Sail Auxiliary - D-7/D-12 Group No. 12 Fuses	June 4, 1981	Bulletin No. 12001 (1003)

Subject: Fuses

D-7/D-12 Electrical Diagrams

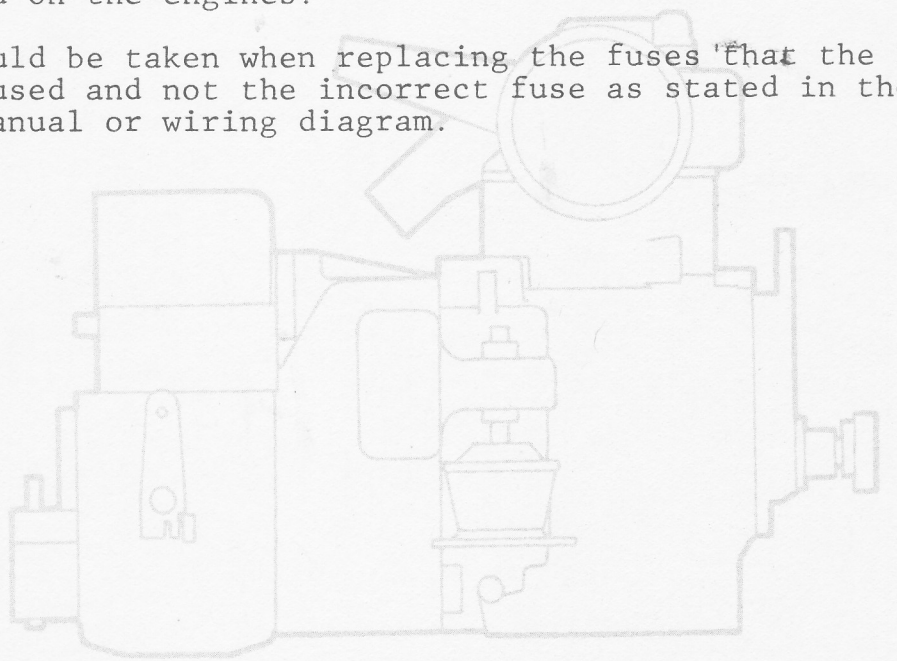
A printing error has occured on the wiring diagram and Owners Manuals for the D-7 and D-12.

The wiring diagram and Owners Manuals show two 8 amp fuses in the electrical system. The correct size fuse is 25 amps. We have been informed the engines have the 25 amp fuses installed on the engines.

Care should be taken when replacing the fuses that the 25 amp fuse is used and not the incorrect fuse as stated in the Owners Manual or wiring diagram.
